Final Environmental Impact Report
Volume 1
for the
Topock Compressor Station
Groundwater Remediation Project

SCH #2008051003

January 2011

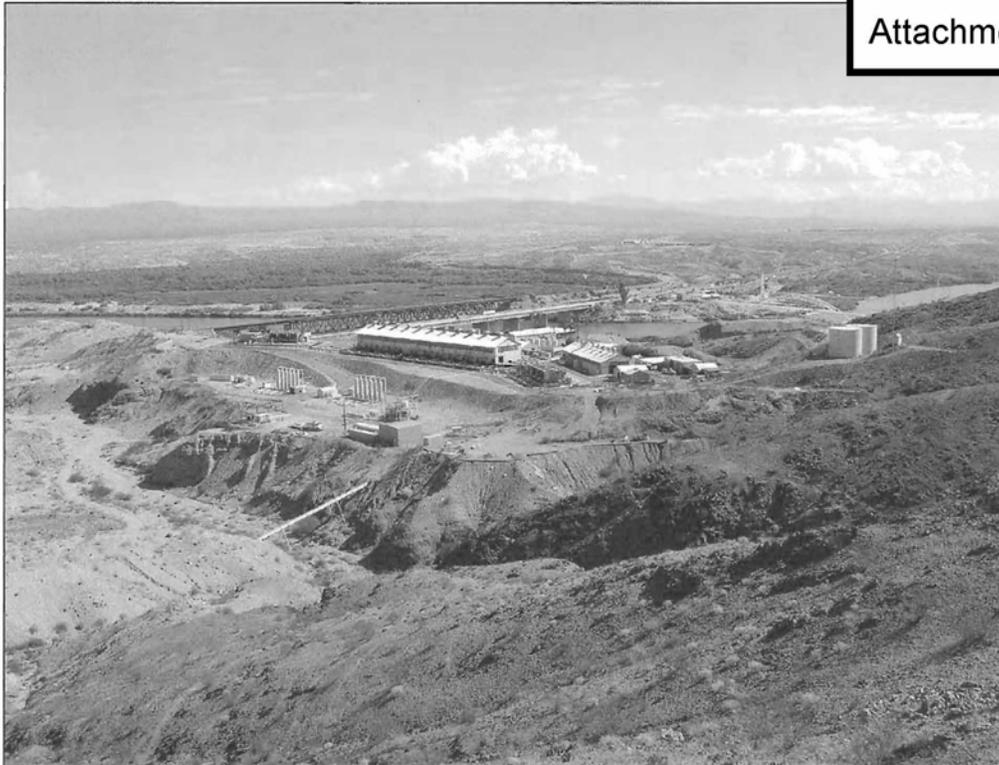
T Has DTSC or DOI technical staff indicated that additional groundwater monitoring wells are needed in this area? If so what were the recommendations? Has DTSC formally requested that PG&E install additional wells in this area? Has PG&E delayed or requested to delay the installation of wells in this area?
Is the extent of groundwater contamination known in this area?
What is the groundwater gradient in bedrock? What is the direction of groundwater flow? Is the contaminated groundwater in contact with the surface or subsurface water of the Colorado River? What is the delay in installing additional wells in this area and determining the extent of groundwater contamination? Is the bedrock fractured in this area? Is there any faults in this area? What was the source of the contamination in this area?

Was it the result of PG&E injecting contaminated groundwater into the aquifer?

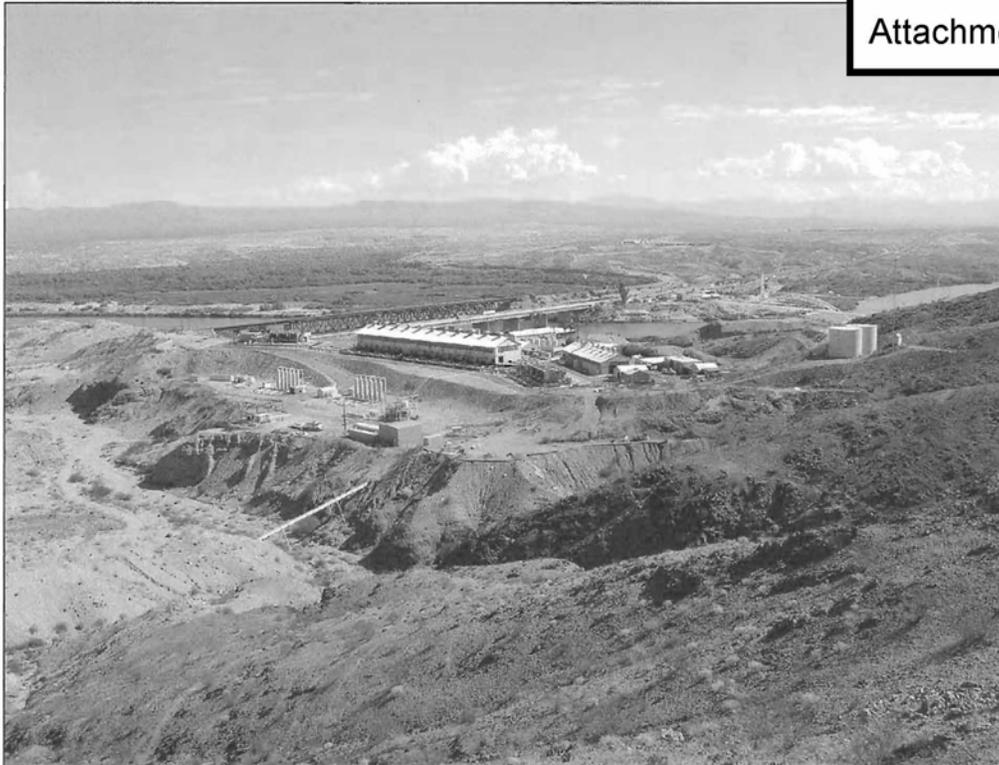
Is the extent of groundwater contamination known in this area?

What is the groundwater gradient in bedrock? What is the direction of groundwater flow? Is the contaminated groundwater in contact with the surface or subsurface water of the Colorado River? What is the delay in installing additional wells in this area and determining the extent of groundwater contamination? Is the bedrock fractured in this area? Is there any faults in this area? What was the source of the contamination in this area?

Was it the result of PG&E injecting contaminated groundwater into the aquifer?
